**7000 Wisconsin Avenue  
Site Plan Submission  
Supplemental Narrative for November 20th Design Advisory Panel Meeting**

This Site Plan submittal is specifically focused on addressing all three of the DAP recommendations from the May 22nd meeting. Each of these recommendations is identified below with a summary of how the Applicant's Site Plan design addresses each comment as well as an analysis of the Proposed Development's compliance with the relevant Bethesda Downtown Plan Design Guidelines (the "Design Guidelines").

**7000 Wisconsin Ave  
Bethesda, MD**

**Design Advisory Panel  
Pre-Submission  
Preliminary Plan and  
Site Plan**

CAR  
PASSING  
EXHIBIT

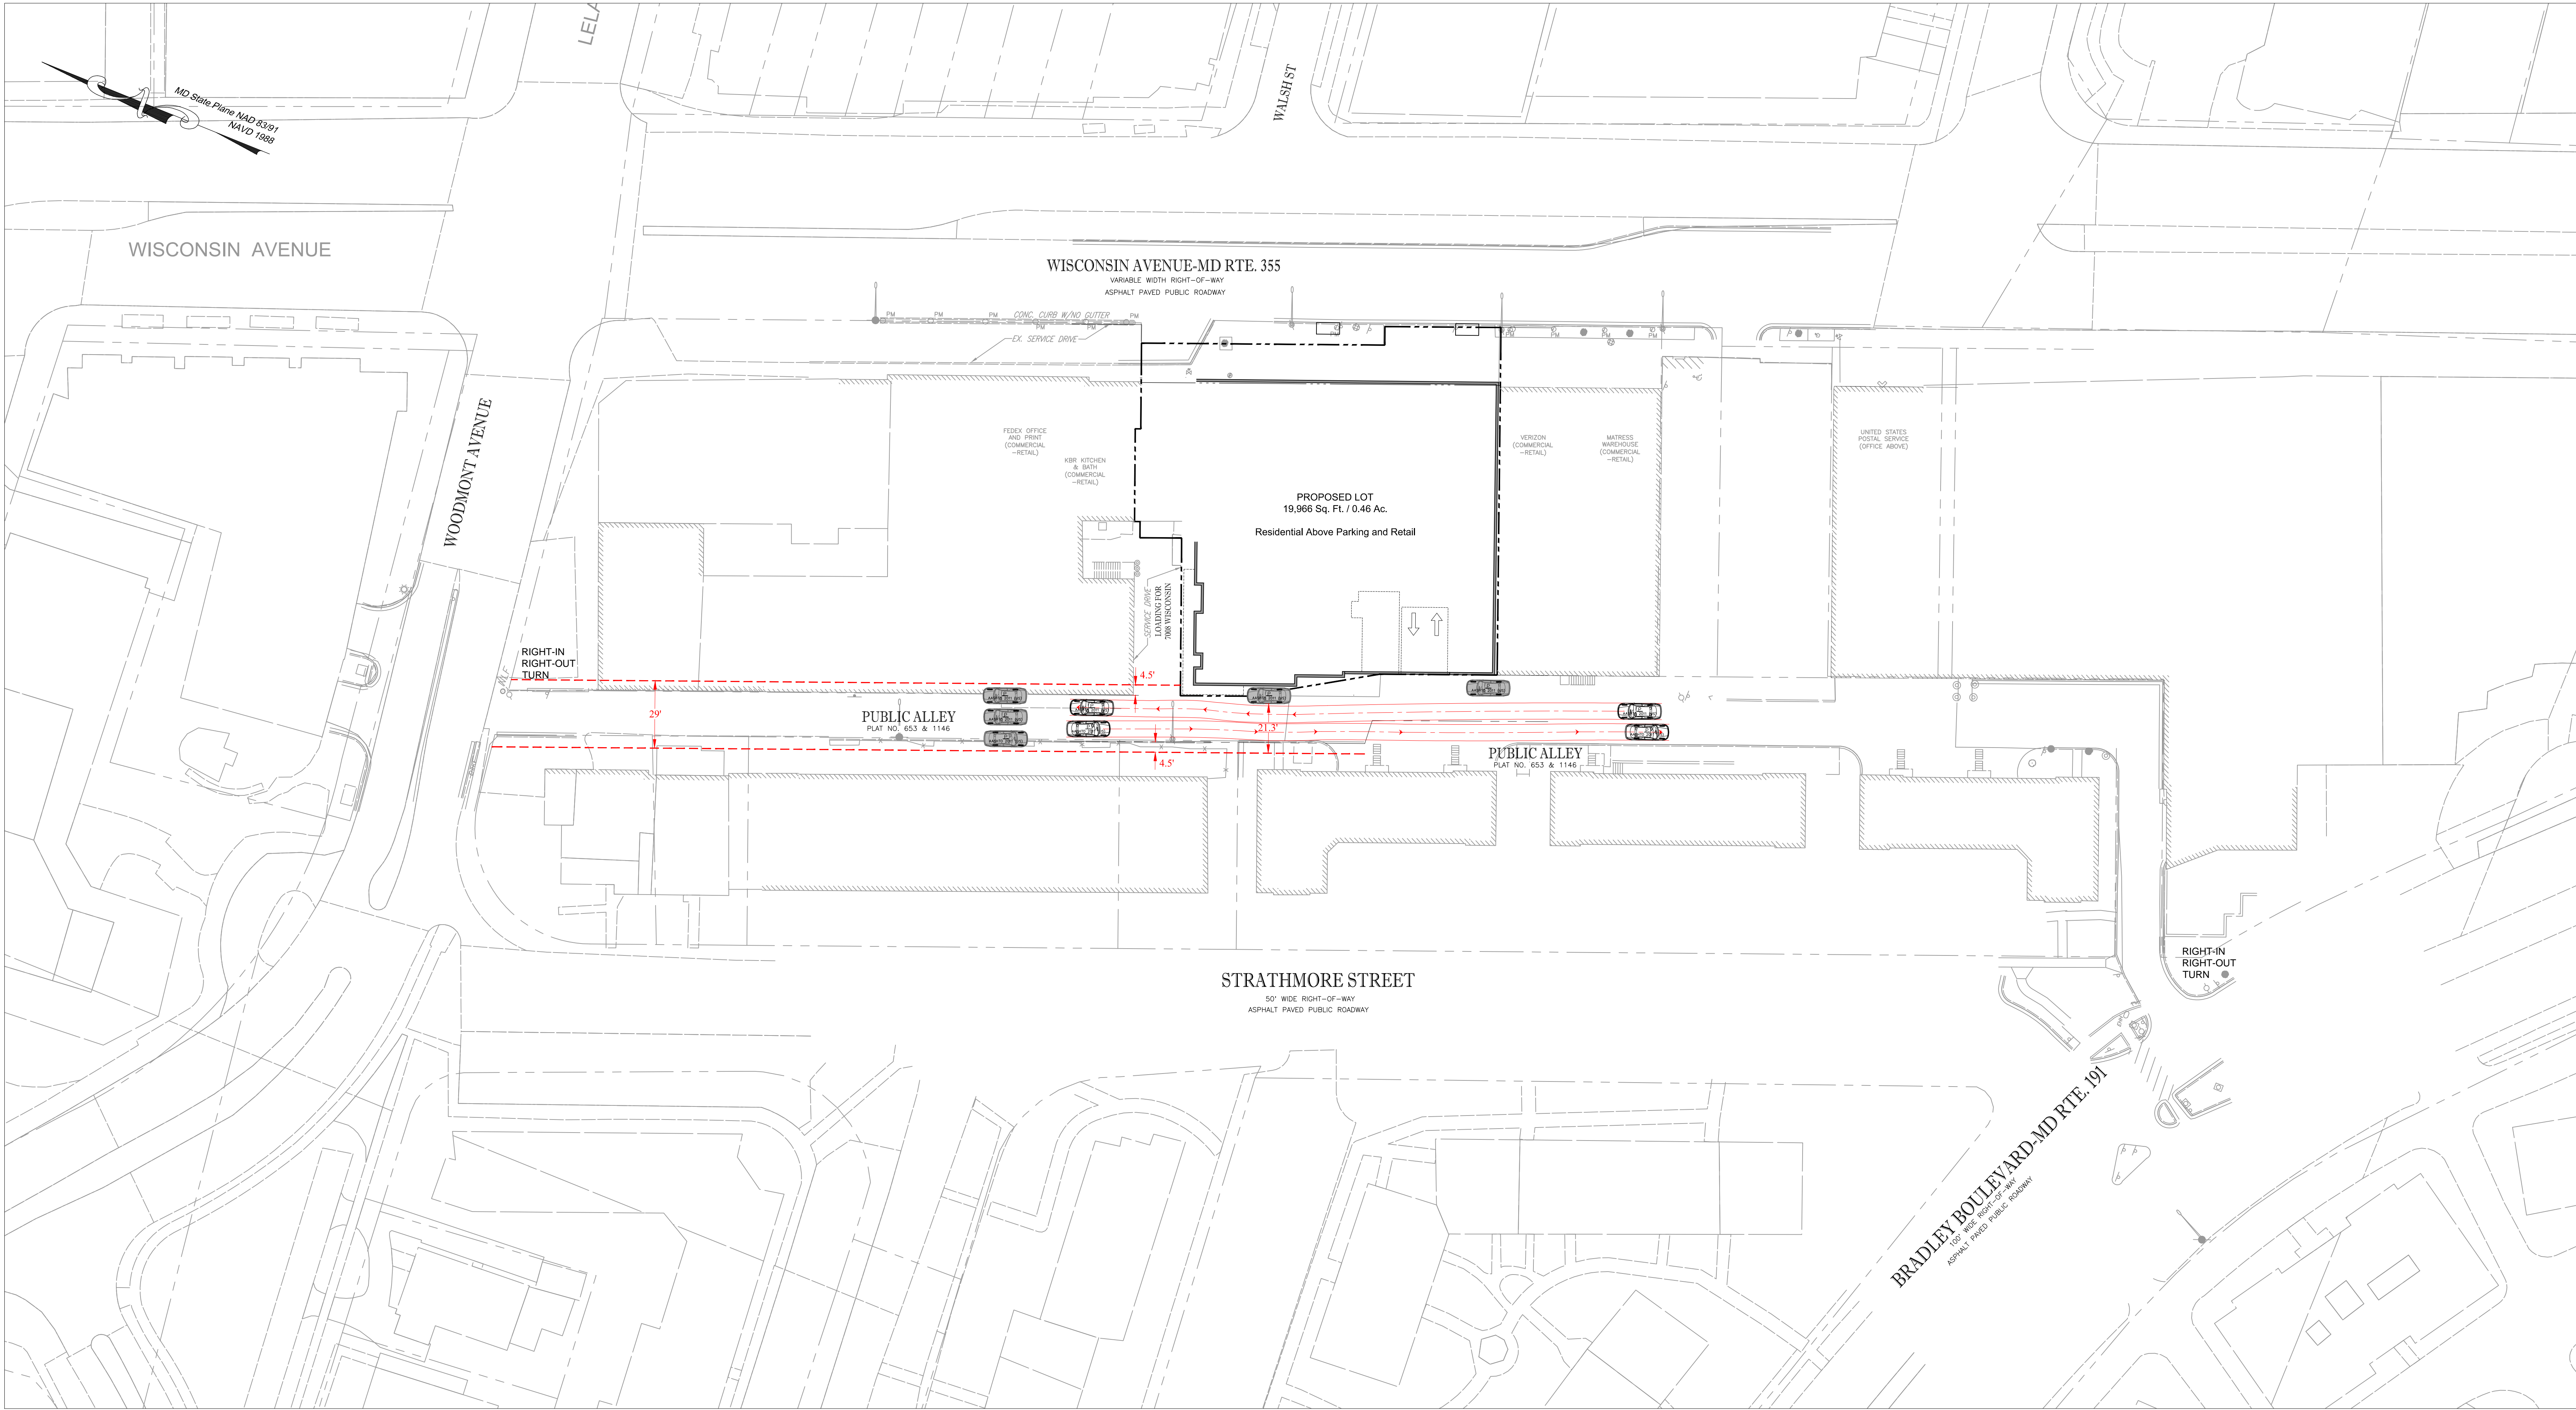
**DAP Recommendation 2.** Provide a clear drawing of the alley connections, dimensions and turning movements for trucks..

1. An existing conditions exhibit that reflects the dimensions of the Public Alley and all connections;
2. A truck turning template exhibit for a 30-foot service truck with the additional alley pavement accommodated by the 4.5' building setback; and
3. A car passing exhibit with the 4.5' building setback, which demonstrates that there is sufficient area for passing (in both the north and southbound travel lanes) when a vehicle temporarily stops in the Public Alley.
